Meeting Agenda

Historic Zoning Commission

Monday, September 30, 2024

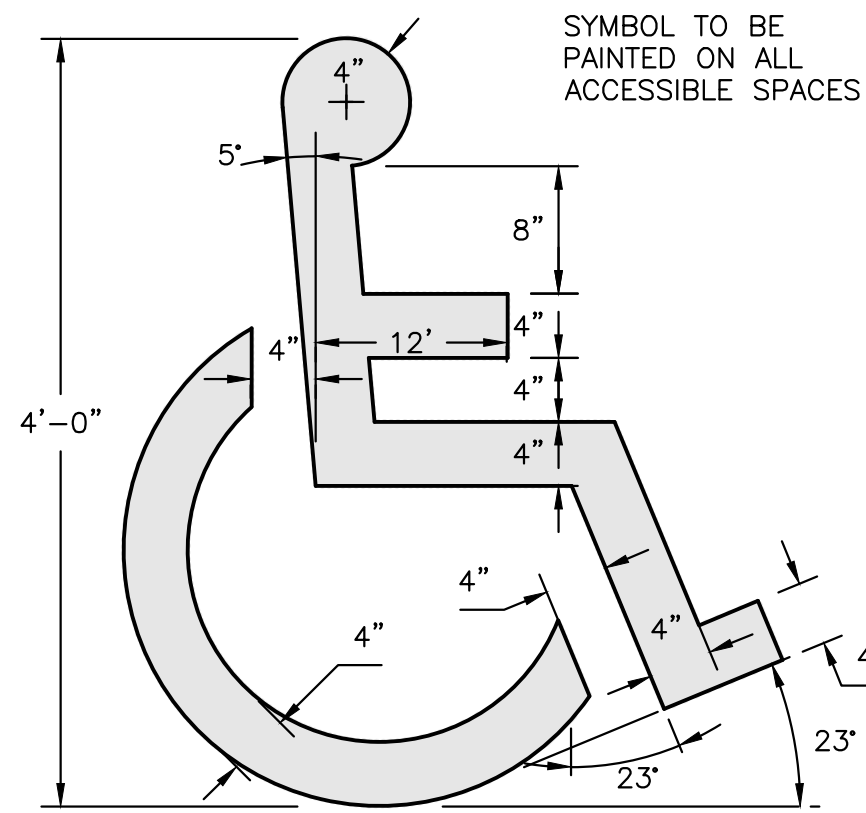
The previously approved ramp does not meet the necessary slopes for the grade that was discovered on site. Although this is a corner lot and side elevation that has a higher degree of visibility, the plantings will help to screen and minimize the visual impact of the ramp.

Staff recommends approval of the ramp with the following conditions:

1. The ramp must match the design and materials of the previously approved ramp. The ramp utilized a wood railing and concrete ramp.
2. The application must meet all the requirements of the City of Franklin prior to issuance of a building permit.
3. Any additional changes to the approved plans must be returned to the Preservation Planner or the Historic Zoning Commission for review and approval.

Marc Campbell Jones
100 Cottage lane
Franklin, TN 37064

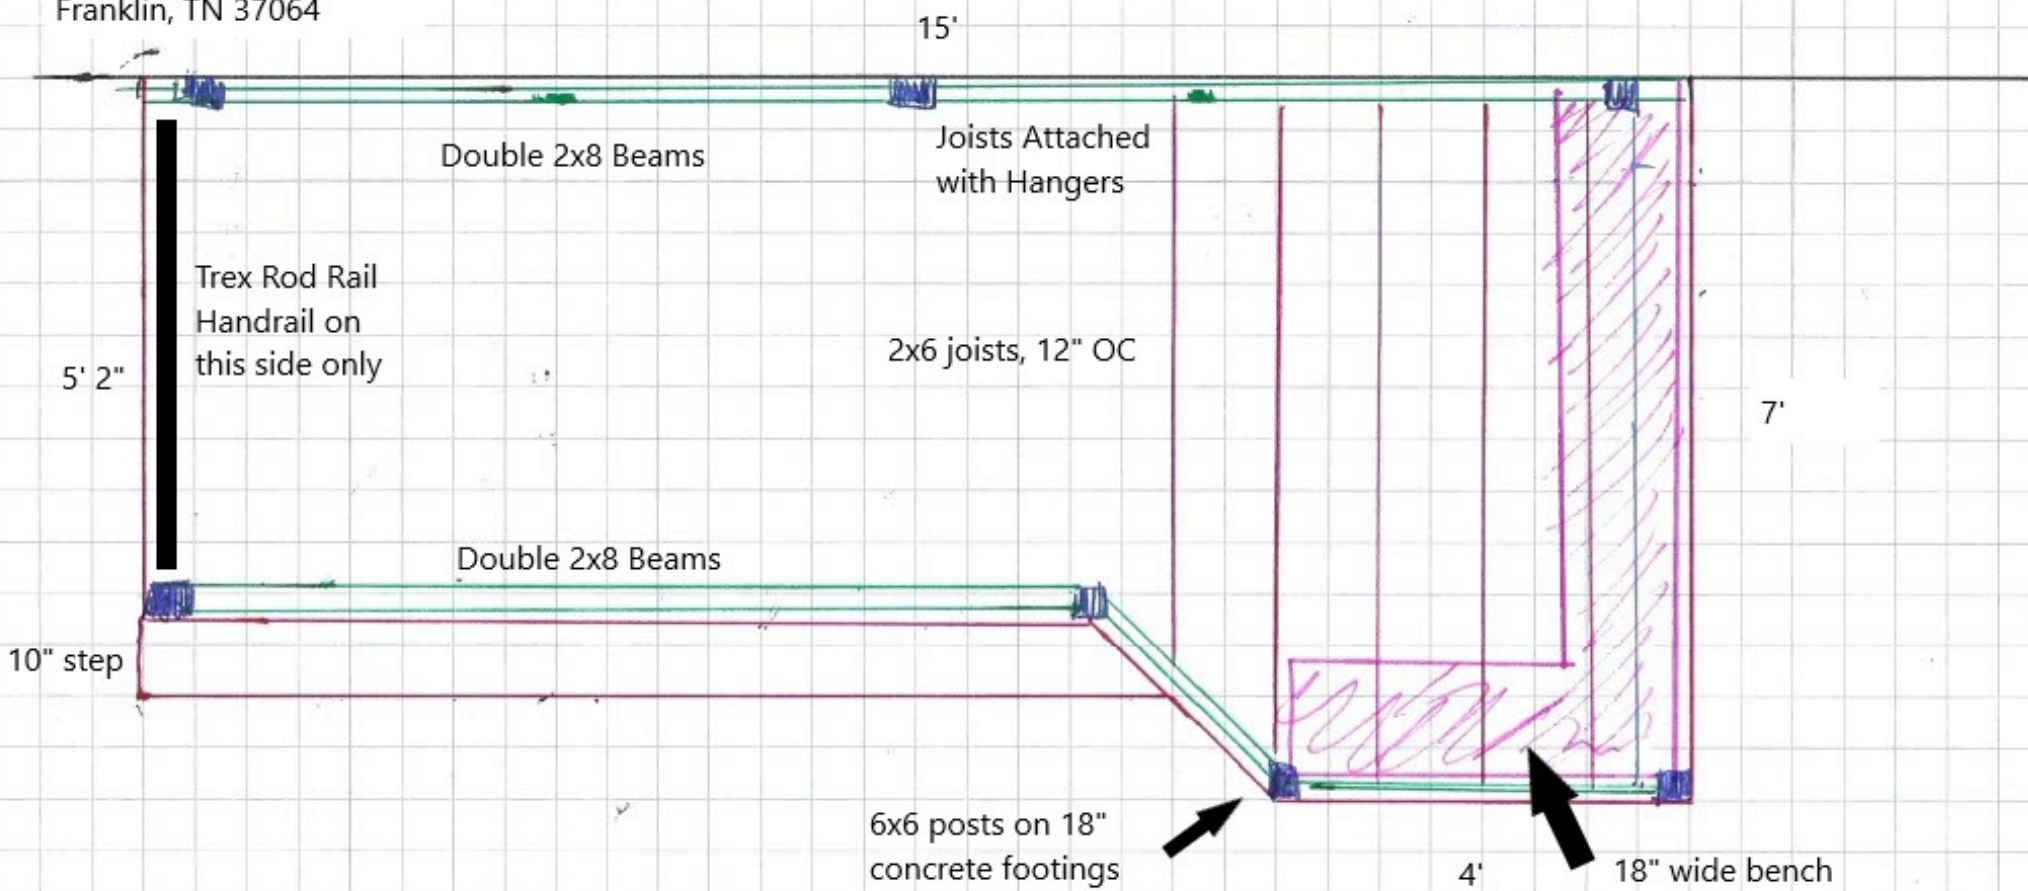
The proposed location of the deck is appropriately placed per the Guidelines, as it is at the rear of the building. However, based off of the plot of the original building, the proposed deck will encroach into the rear setback, right up to the property line. Based on Section 3.10 of the Z.O., appurtenances within the Planned District may encroach into a rear yard a maximum of 15' but no closer than 15' from the lot line. A variance would need to be requested for the placement of this rear deck.

1. Based off of the plot plan for the original home, the proposed deck will encroach into the rear setback, right up to the property line. Based on Section 3.10 of the Z.O., appurtenances within the Planned District may encroach into a rear yard a maximum of 15' but no closer than 15' from the lot line. BNS staff cannot approve this request without a variance.

1. If a variance for the location is not granted, the structure must be set back 15' from the property line.
2. The application must meet all the requirements of the City of Franklin prior to issuance of a building permit.
3. Any additional changes to the approved plans must be returned to the Preservation Planner or the Historic Zoning Commission for review and approval.

FIRST FLOOR PLAN // PROPOSED

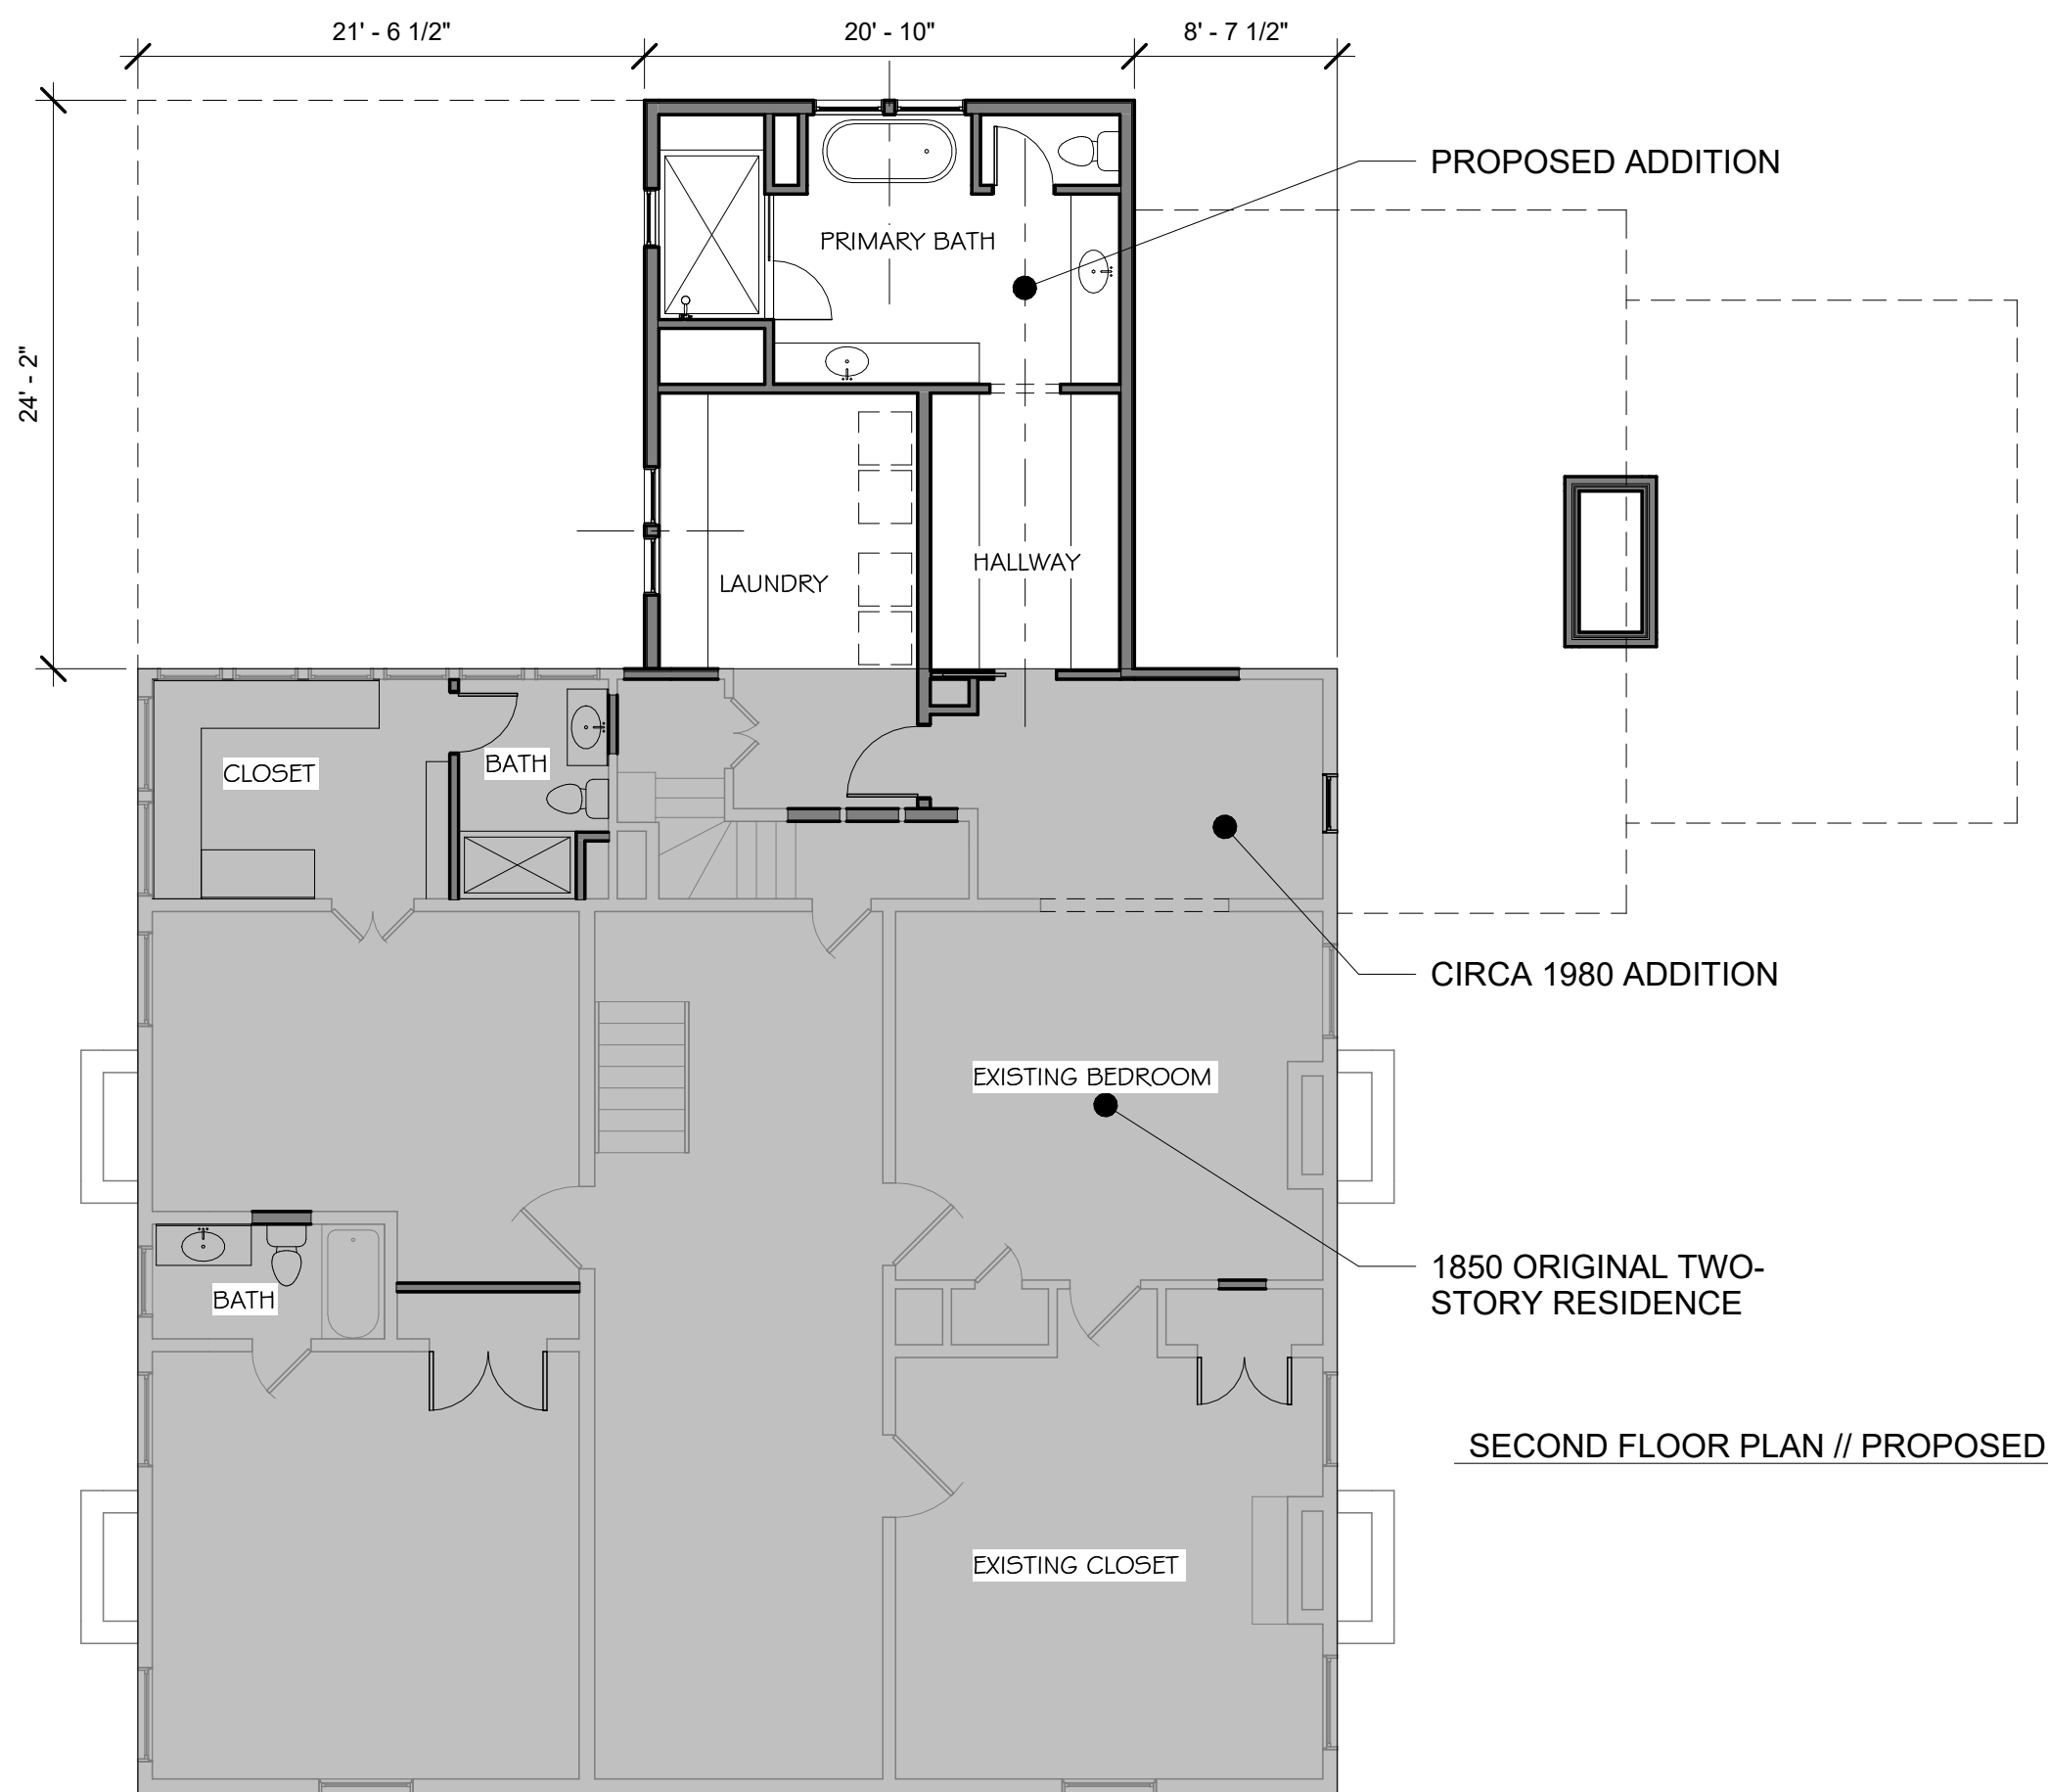
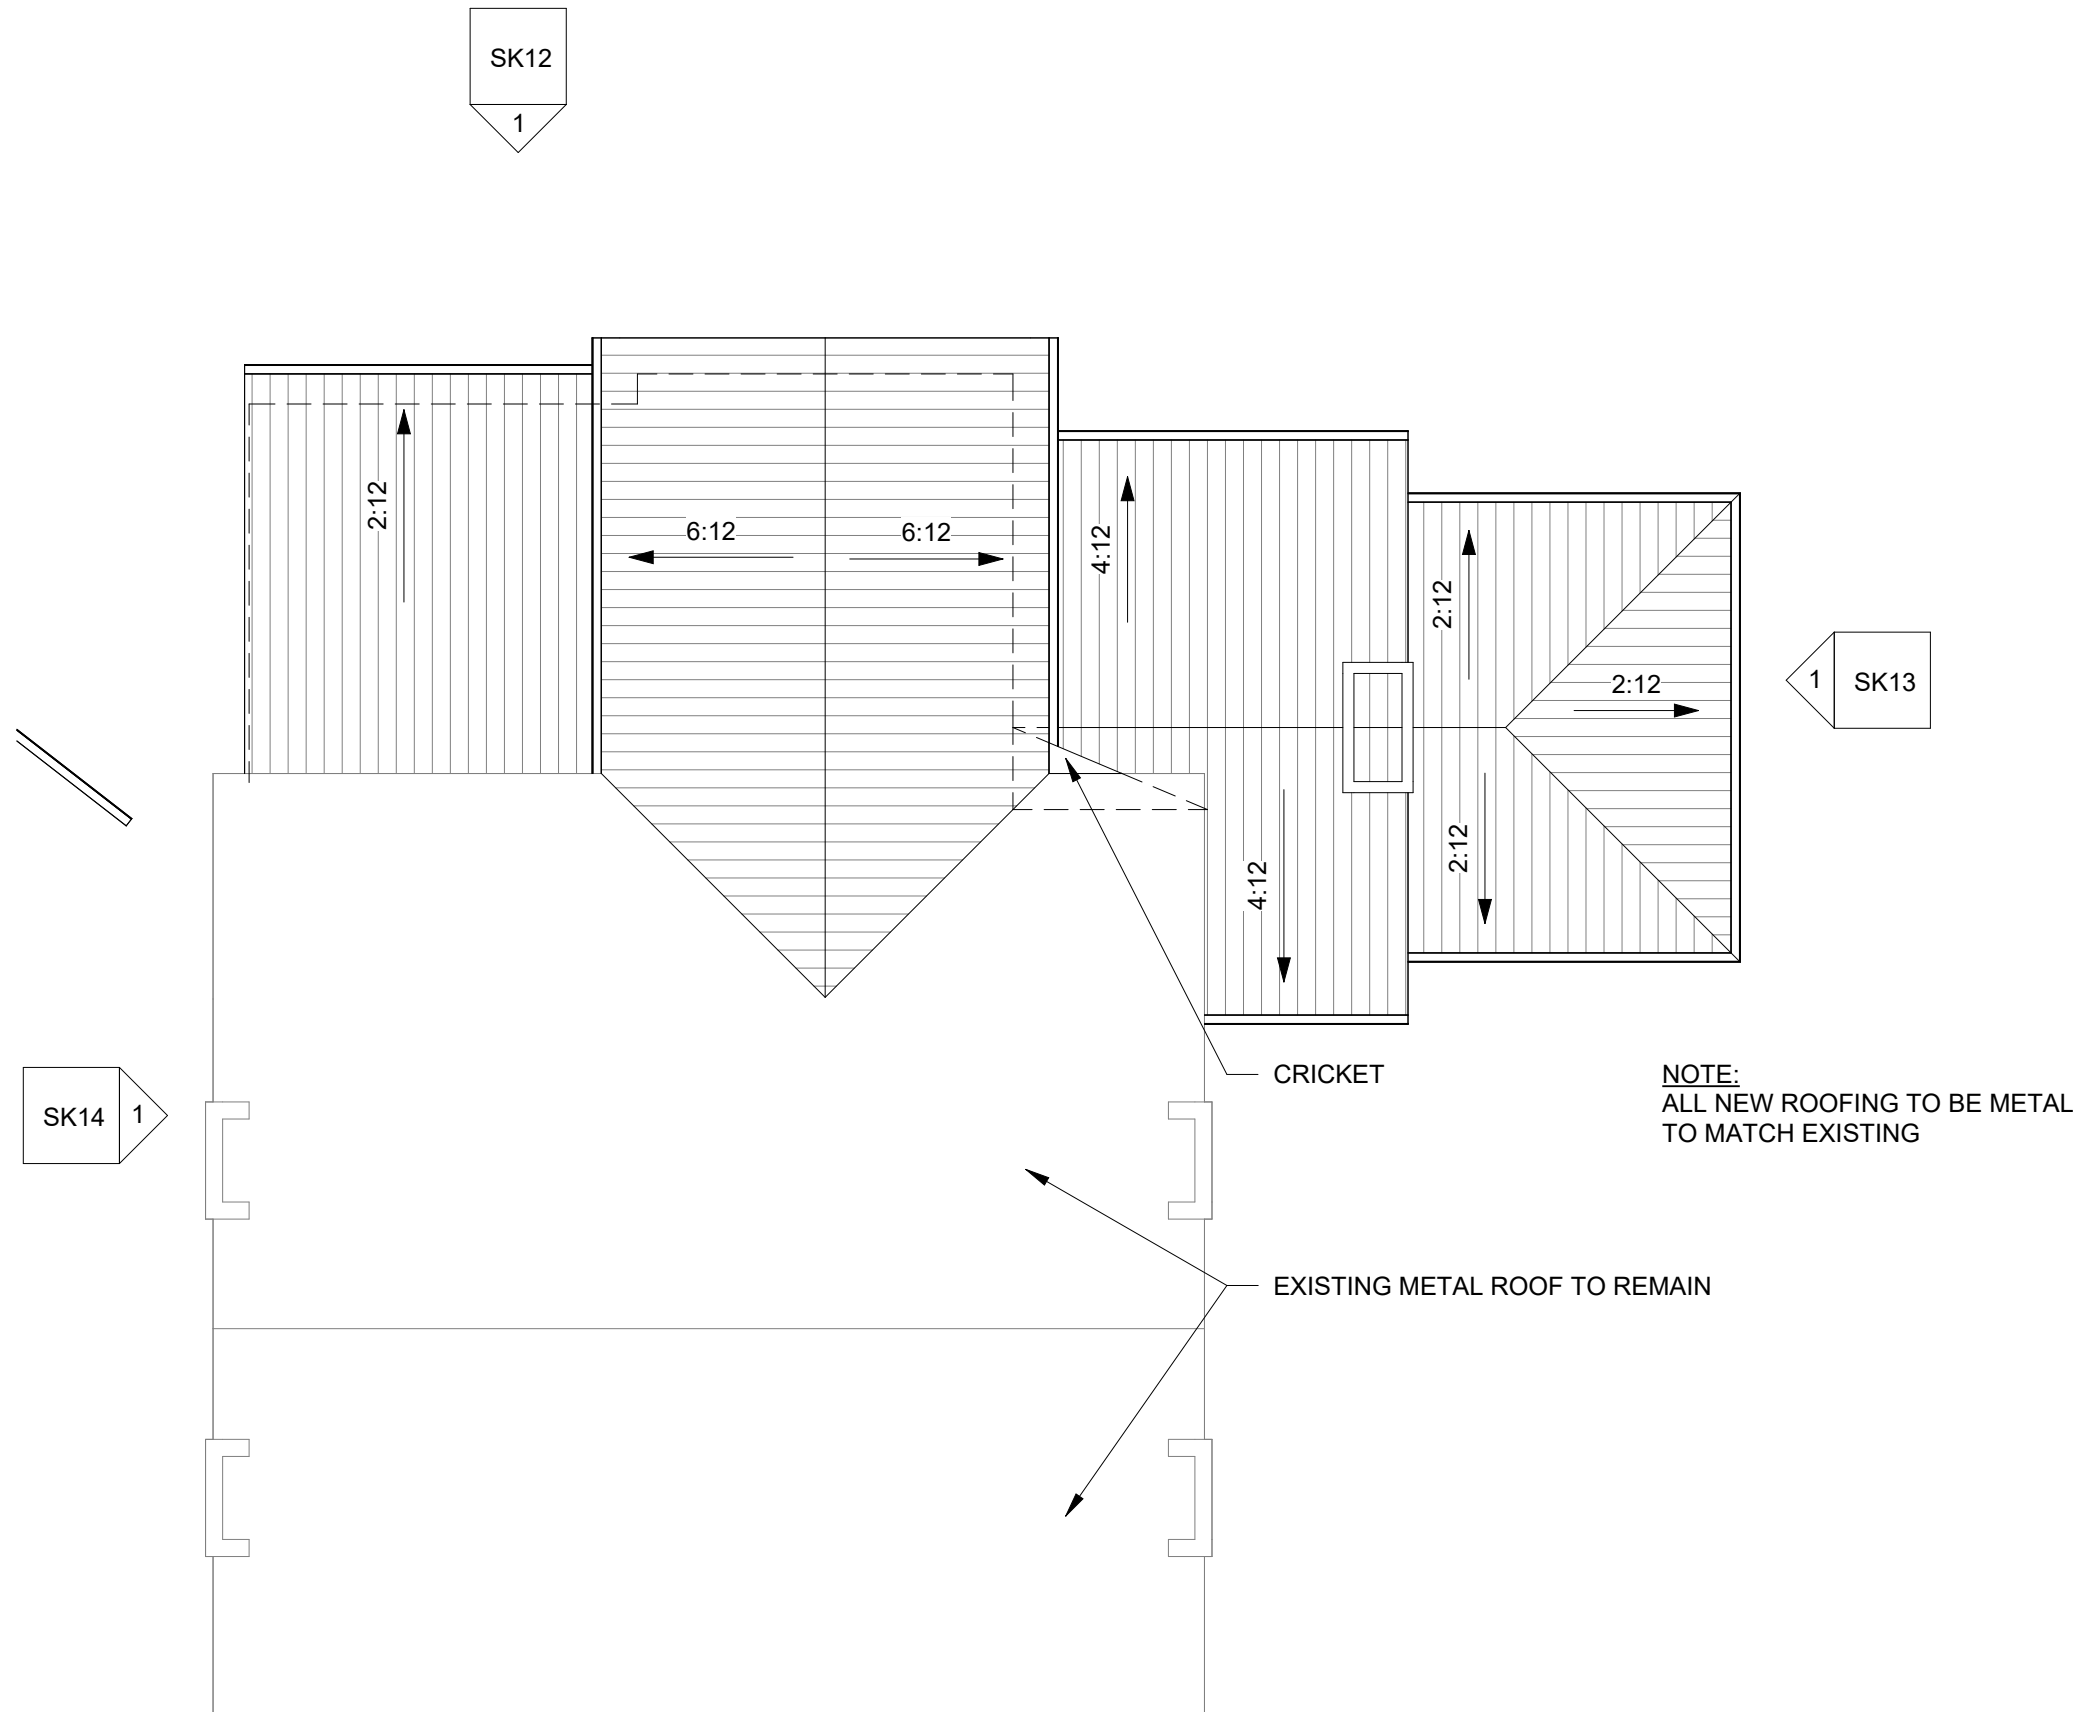
The proposed addition would add approximately 927 sq. ft. to the footprint of the home. The existing historic footprint of the home is 2,133 sq. ft. The addition is appropriately sized, being 43% of the historic footprint. The Guidelines recommend that additions be subordinate to the historic building and should not exceed 50% of the historic building's footprint. The addition, along with all of the structures, equates to a total lot coverage amount of 0.02%. This is appropriate as the Guidelines recommend not to exceed 35% of lot coverage. The orientation, form, and size of the addition that is being proposed are appropriate.

The rhythm and placement are traditional and provide continued symmetry that is typical to the neoclassical style. The windows are more compatible in size and detailing to those on the historic building.

1. Window specifications showing three-dimensional cut-outs with dimensions must be provided to the Preservation Planner before the Building Permit submittal.
2. The reveal of the siding on the addition must match the existing siding on the building.
3. The application must meet all the requirements of the City of Franklin prior to issuance of a building permit.
4. Any additional changes to the approved plans must be returned to the Preservation Planner or the Historic Zoning Commission for review and approval.
